Table of Contents for 504 East 8th Street Tree Permit
Heritage Tree Variance Package

**ADDRESS
OF PROPERTY:** 504 EAST 8TH STREET

TREE PERMIT #: ROW ID 11422103

SUBJECT: 504 East 8th Heritage Tree Ordinance Variance

Exhibit 1

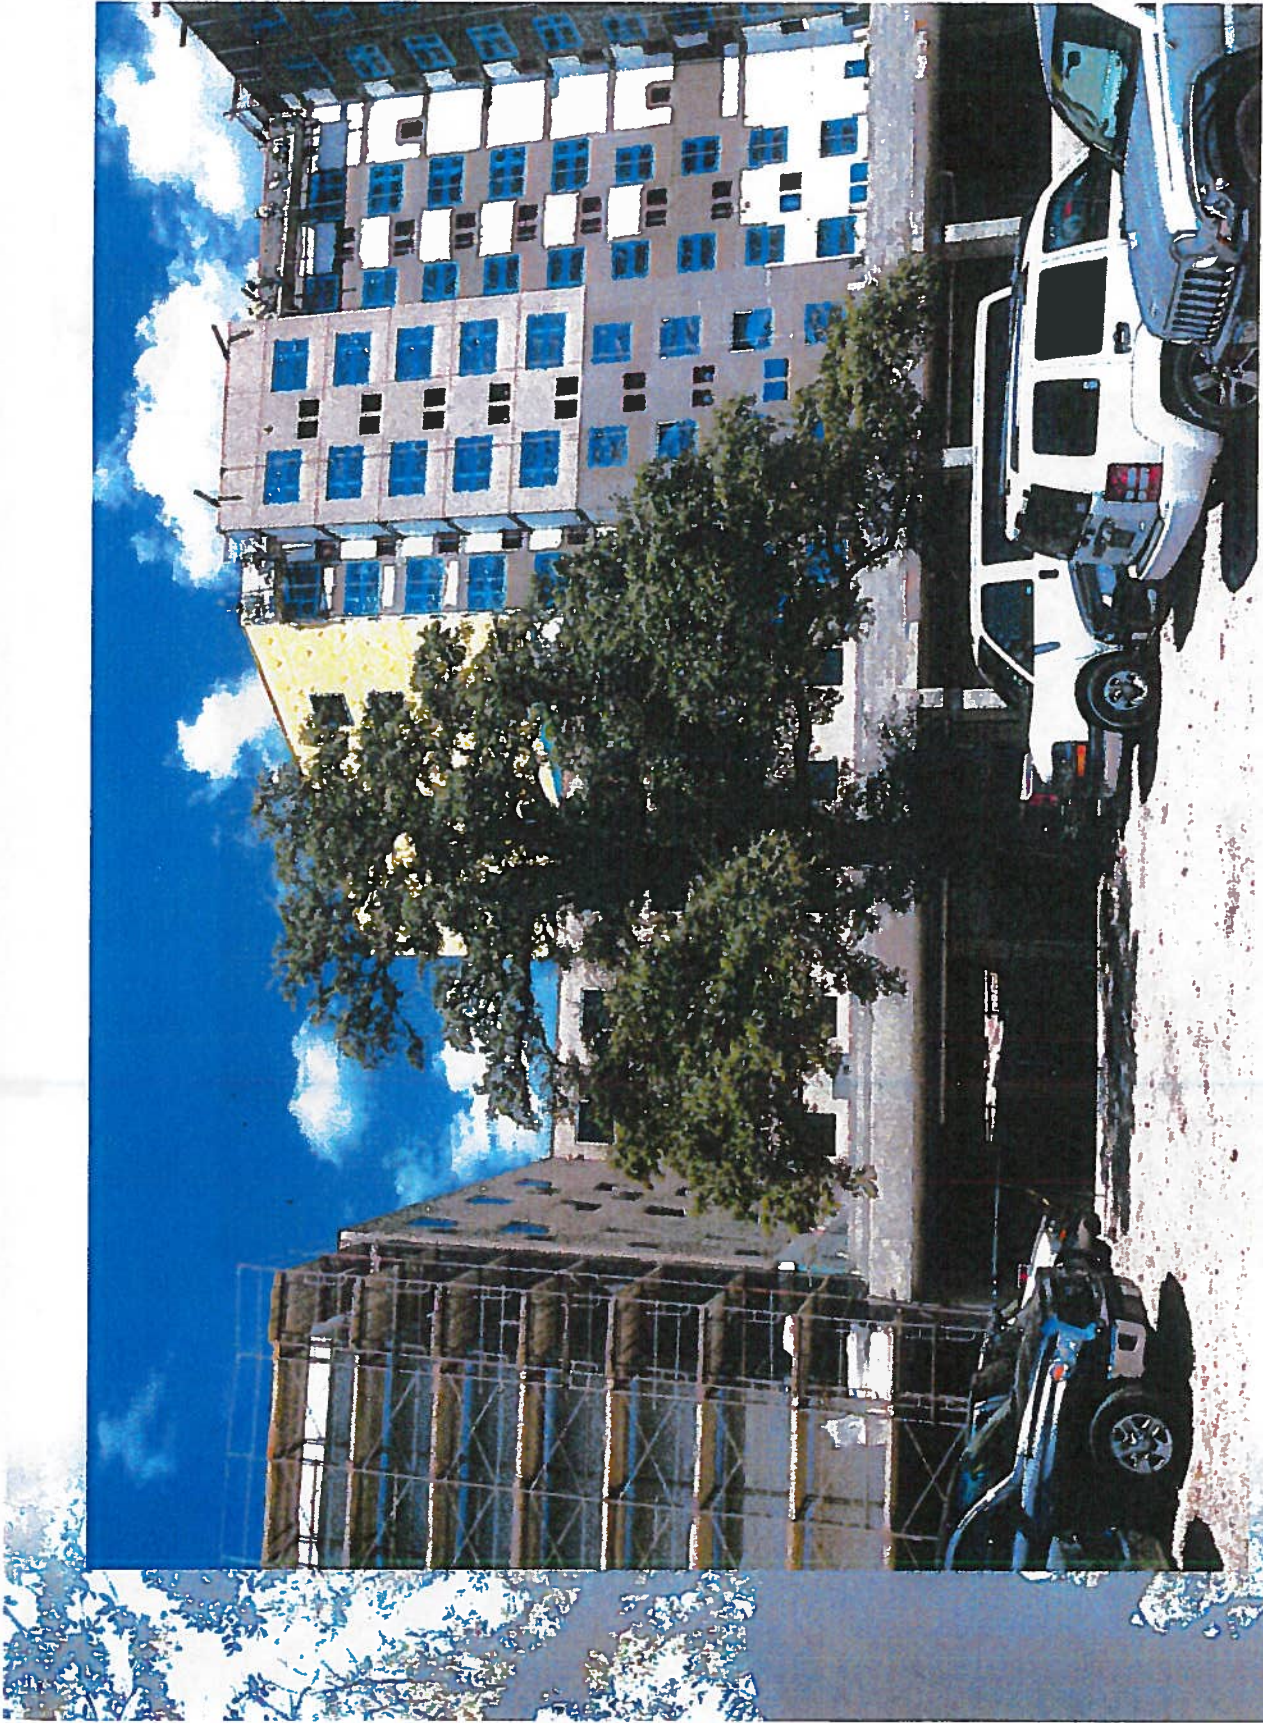
The canopy architecture displays minor asymmetry (Exhibit 1). Storm damage is evident in the canopy as the main leader has been damaged (Exhibit 2). Extensive epicormics growth is apparent (Exhibits 3 and 4). Epicormic growth is generally associated with the tree's response to stress likely related to the root system (see below).

Exhibit 4

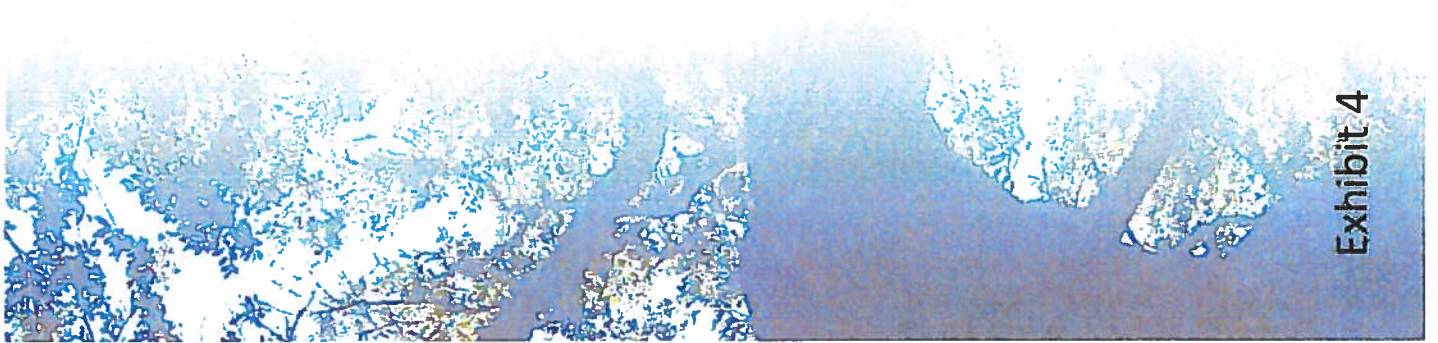
Storm damage is apparent in lower limbs (Exhibit 5). Otherwise, unremarkable.

Exhibit 5

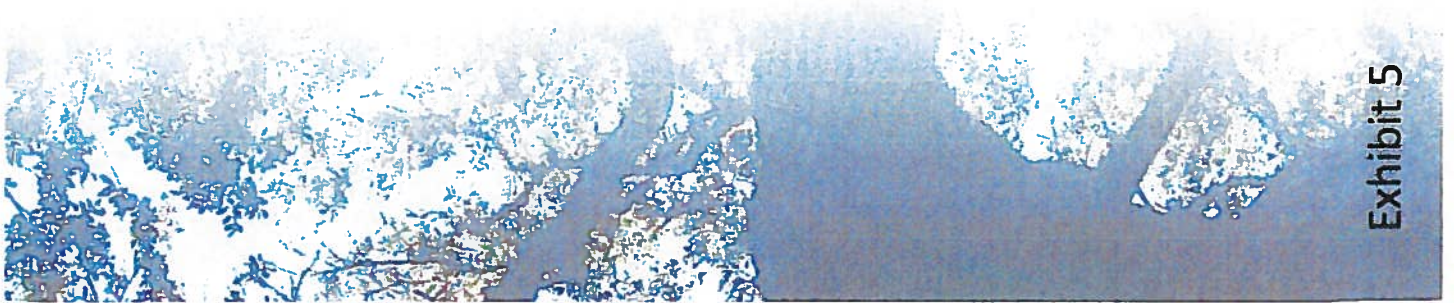
Root flare is buried under fill material (Exhibit 6). Critical root zone conditions are characterized by compacted parking areas (Exhibit 7) and cut on the northern half of the critical root zone (Exhibit 8). Girdling roots are present (Exhibit 9). Root decay is present. Extent of root decay is unknown but is a concern.
